Draft Corrigendum to ECE/TRANS/WP.29/GRSG/2016/13**I. Proposal**

Figure 3

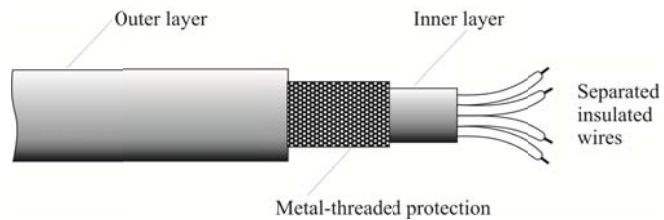
New paragraphs 5.1.1.2.1. and 5.1.1.2.2., correct to read (inserting existing Figures 1 to 4):

5.1.1.2.2. Additional Protection

Cables located ...

... or one of the examples in Figures 1 to 4 below or another configuration that offers equally effective protection is used.
